**SUBJECT: REPLY TO NMED COMMENTS ON MAIN AQUIFER WATER LEVEL
MAPS FOR LOS ALAMOS NATIONAL LABORATORY**

This letter addresses "New Mexico Environment Department Hazardous and Radioactive Material Bureau response to DOE deliverable, dated December 27, 1994, to EPA on 'Water-Level Maps for Los Alamos National Laboratory (LANL)' ", dated January 23, 1995.

1993 Main Aquifer Water Levels using White Rock Canyon Springs, Test Wells, and Water Supply Wells

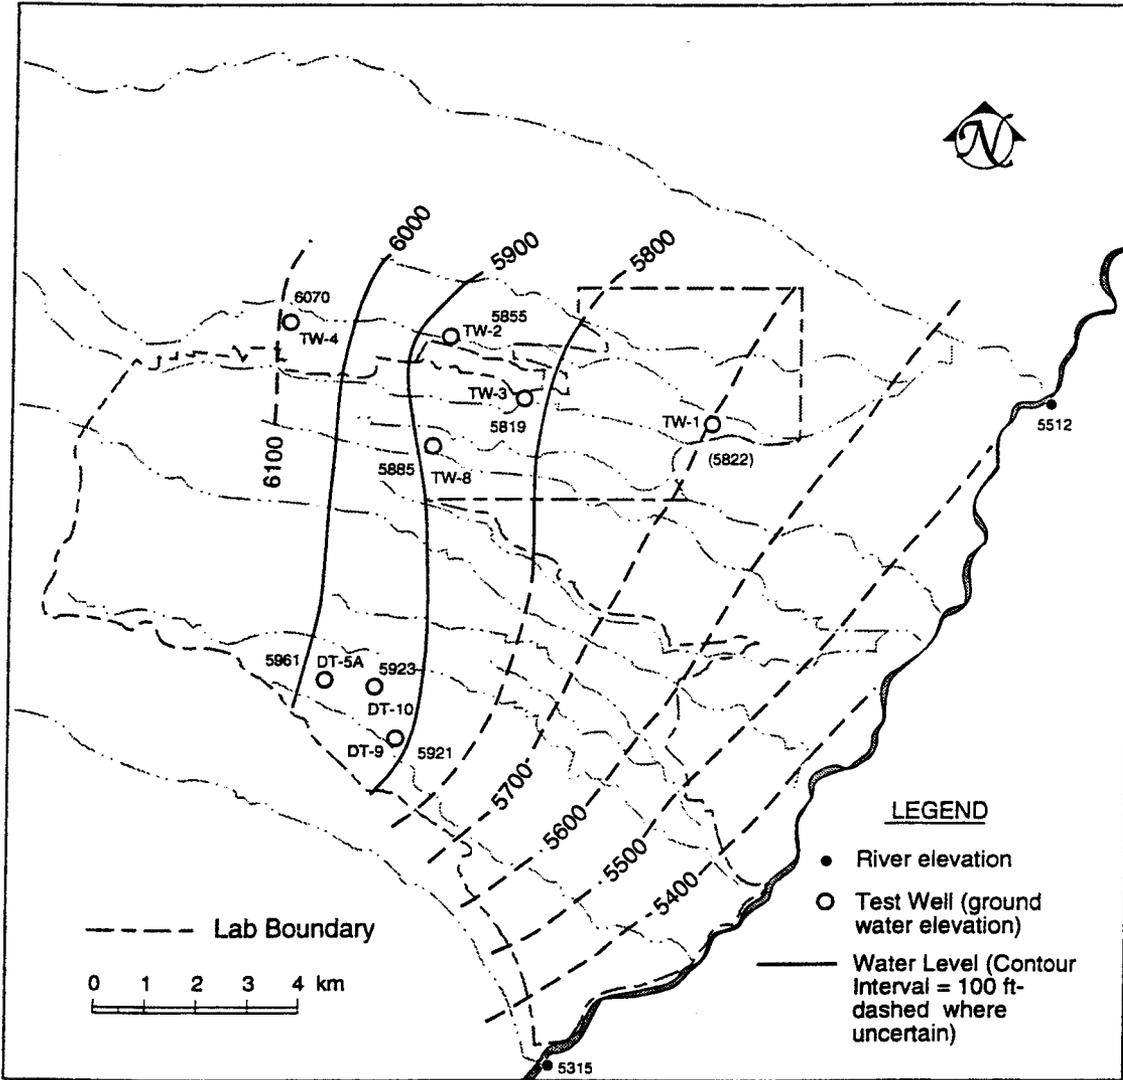
2) The supply well data represent vertically averaged water levels; it is not accepted practice to contour such data. Compiling such data will probably give a misrepresentative picture of the hydraulic head distribution within the aquifer(s).

4) There are no data to support the 6300 through 6100 ft contour lines. A number of wells have values which are not honored by the contour lines.

12) Wells TW-1 and TW-2 should read TW-1A and TW-2A.

It is preferable to use water level data from within a single hydrologic unit when constructing water-level maps. Such information is seldom available, and the hydrologist must make an interpretation based on limited data. Our map was in accordance with our agreement with EPA, that we would produce the best possible main aquifer potentiometric map which could be generated, which would include static water levels measured at the eight test wells, and non-pumping water levels at the operating water supply wells.

In order to determine the impact of using water supply wells to draw a water level map, five maps are attached. These maps depict the water table in the Los Alamos area at different times, and using different sets of data. The first shows 1993 main aquifer water levels using springs, test wells, and supply wells; this is the same map that we previously submitted to EPA.

First, our agreement with EPA was that we would "depict, very approximately, the actual conditions of the main aquifer". For the 6300 through 6100 ft contour lines, which are a reasonable projection of the information, dashed contours would have been appropriate. Regarding the fact that the contour lines do not fit a number of wells, this is to be expected from the use of both deep and shallower wells to construct the map. A better solution might have been to emphasize test well data in regions where wells have different water levels. Some interpretation and smoothing are required to obtain a reasonable picture of the piezometric surface.

This was a typographical error in the text and on the map.

1960 Main Aquifer Water Levels using Test Wells and Rio Grande elevations

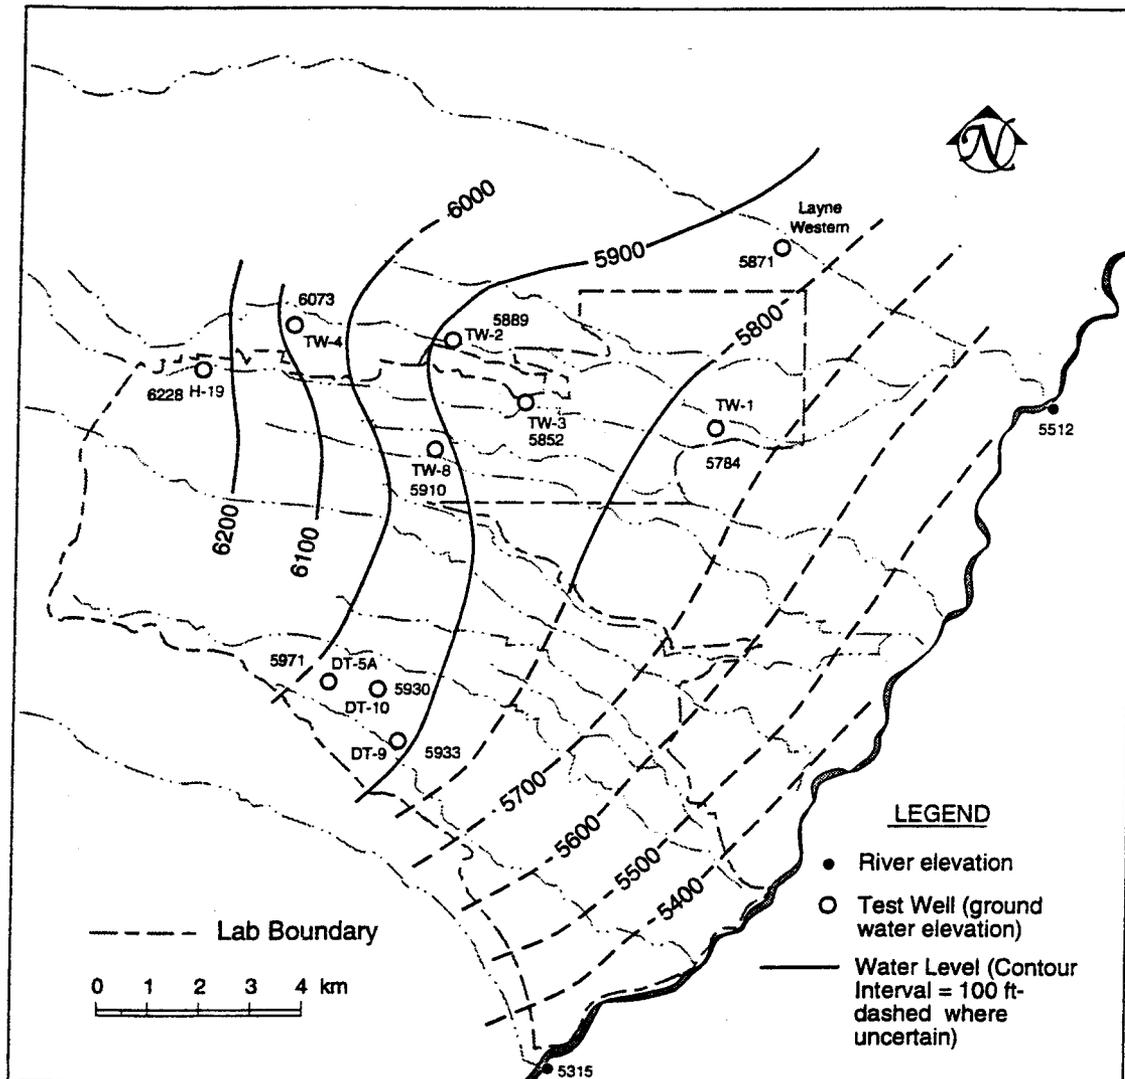
3) The reasoning for including the 1949 groundwater elevation data from well H-19 is inadequate, despite the fact that the water level in TW-4, one-half mile to the east, had not changed significantly in the last 45 years... "a change of seven feet in the groundwater level must also be considered not significant". The use of 1949 data for water-level measurements during December 1994 (sic) is not accepted practice.

The third and fourth maps show main aquifer water levels using test wells, for 1960 and for 1949-50. The latter map is a hybrid, including the 1960 water levels for TW-8, DT-5A, DT-9, and DT-10. For this reason, the 1960 map is also included. The 1949-50 map includes test well H-19 and the Layne Western well, drilled as a pilot for the Guaje Well Field (Purtymun, 1995). The geographic location of this latter well greatly improves the quality of the map. The 1949-50 and 1960 maps show little difference. Except for the 5700 and 5800 ft contours, these maps also differ little from the USGS pre-development map which we previously submitted to the EPA.
